SERVICE

BULLETIN

SB #: F171
DATE: MAY 2021
TO: ALL AUTHORIZED FERRIS DEALERS
SUBJECT: IS6200 RIGHT ANGLE GEARBOX
 OIL LEVEL CHECK

**Figure 1. Gearbox Oil Fill Plug****Figure 2. Skid Plate**

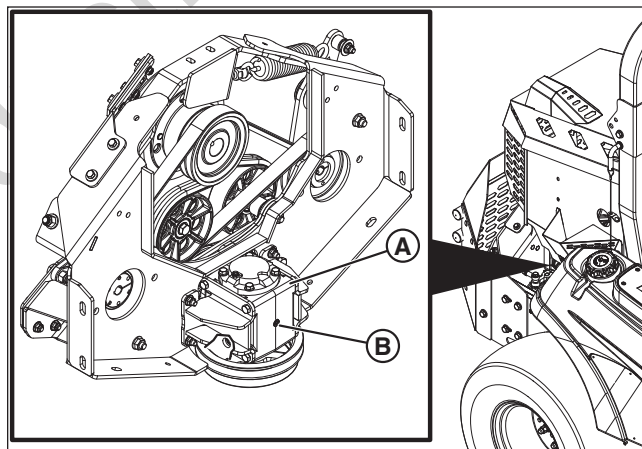
Ferris has identified that the right angle gearbox (**A, Figure 1**) that drives the mower deck, may not have been filled to the appropriate level from the manufacturer.

1. Remove the skid plate (**A, Figure 2**) and two retaining bolts, washers, and nuts (**B**) for easier access to the gear box.
2. The gearbox's oil fill plug (**B, Figure 1**) is located on the front of the gearbox. Remove the fill plug from the gearbox.
3. Once the fill plug is removed oil should seep out of the fill plug hole. If no oil drains out, fill with Amsoil® SAE 75W-140 weight gear oil (or equivalent) until oil starts to seep from the hole and then replace the fill plug.
4. Install the skid plate (**A, Figure 2**) with the retaining hardware (**B**).

If the oil level is determined to be insufficient, add the recommended Amsoil® SAE 75W-140 weight gear oil (or equivalent).
